SERVICE BULLETIN

Four-Ball Pump Changes

LOWER PUMP ENDS AFFECTED: 6720X-X

RELEASED: 7-6-99
REVISED: 1-10-12
REV: 00
BULLETIN: #5-99
FORM: 4336-2

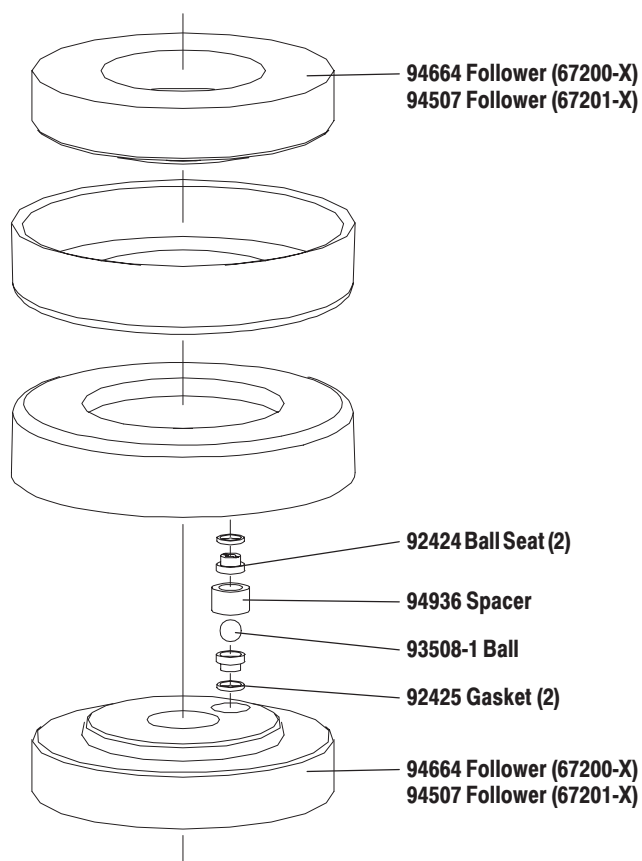
Changes affect models built after 6-30-99 (SN F9309XXX).

The following changes were made to 6720X-X Lower Pump End.

- 1.) Add 92425 gaskets (2).
- 2.) Add 92424 ball seats (2).
- 3.) Add 93508-1 ball.
- 4.) Add 94936 spacer.
- 5.) 94507 and 94664 followers are machined to accept the items listed above.
